Economic Commission for Europe

Regulation No. 58 (Rear underrun protection)

Proposal for amendments to Regulation No. 58 (Rear underrun protection)

Submitted by the expert from Germany*

Figure 1

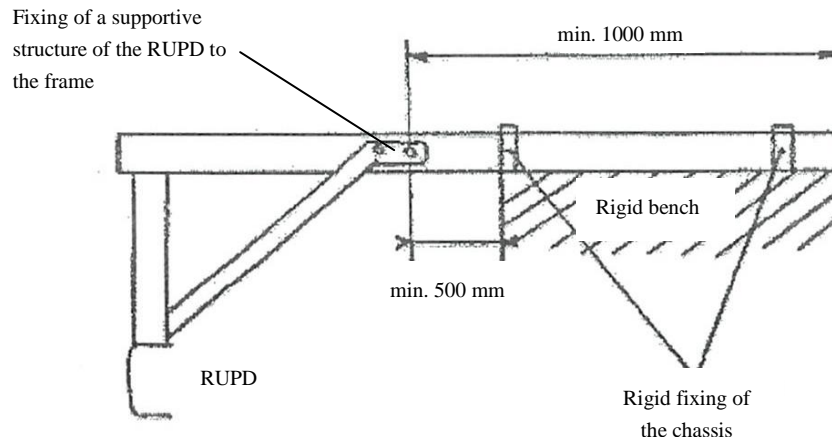
Paragraph 1.1.3., amend to read:

- "1.1.3. On a rigid test bench (see Figure 1, representing the minimum requirements to be fulfilled).
